Substantive response of the Local Highway Authority to a planning consultation received under The Development Management Order.

Planning Application Number: 24/00914/OUT

Application Address: Burroughs Road Recreation Ground Burroughs Road Ratby Leicester Leicestershire LE6 0XZ

Application Type: Outline (with access)

Figure 3: Details of Desford Road scheme of mitigation as shown in Figure 13 of Pell Fischmann Transport Assessment Addendum

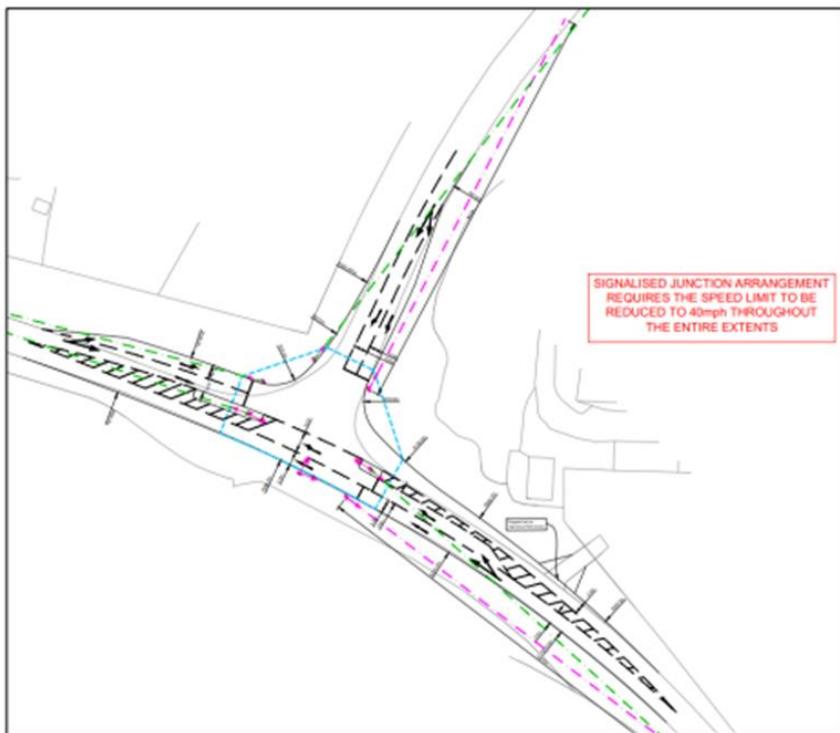
The LHA has reviewed the proposed highway works at the Desford Lane junction shown on Drawing number: 109003 PEF ZZ XX DR TP 00010 Desford Lane Junction Improvements, Revision P01 and the tracking shown on Drawing number: 109003 PEF ZZ XX DR TP 00011 16.5m HGV Tracking Through Junction Improvement Desford Lane Revision P01.

The LHA accepts the applicant's conclusion that a signalised junction would mitigate the impact of the proposed development. The applicant should note the following comments which can be addressed in an updated drawing(s) should the applicant wish to do so:

- The applicant should show on the drawings the existing service road on the northern arm that serves several properties.
- Lane widths are in accordance with DMRB CD123 Para 7.8 and 7.9.

- The LHA believe the corner radii should be in accordance with DMRB CD123 Para 5.6.2 i.e. 15m as it is in a rural area and should cater for articulated HGVs.

- Visibility to Signal Heads is shown based on an assumed reduced speed limit of 40mph, and these are in accordance with the DMRB CD123 Para 7.3, apart from the northern arm where only 90m is achievable. DMRB states that the visibility shall be in accordance with Table 2.10 of DMRV CD109 and therefore relaxations are not permitted.

- Formation of the left turn lane on the west arm and north arm should be dimensioned and shown to be in accordance with DMRB CD123 Para 7.10.
- Formation of the right turn lane on the east arm should be dimensioned and shown to be in accordance with DMRB CD123 Para 7.10.2

- Inter Junction Visibility Splays are shown and are in accordance with DMRB CD123 Para 7.4.

- The highway boundary is not shown on the drawing, but the LHA believes that all the construction works and displayed visibility splays are within the adopted highway boundary.
- The tracking drawing shows all the required vehicle manoeuvres at a speed of 15kph as per the LHDG.
- The tracking drawing line weights are quite thick and suggest that several movements will result in the vehicle overrunning the kerbline – left turn out of northern arm, left turn into northern arm. Therefore, some further amendments to the design of the scheme will be required.
- The drawing also suggests that vehicles will be overrunning the lane lines when turning – left turn out of northern arm and the left turn into northern arm.

Notwithstanding the above the scheme of mitigation has currently not been supported by a Stage 1 RSA and Designers Response to any issues raised and the applicant has not provided a swept path analysis of a larger 18.5 HGV to demonstrate that all turning movements by a large articulated HGV can be accommodated.

This will need to be addressed by the applicant as part of a revised set of drawings or as part of the Discharge of Condition application subject to receiving planning permission.
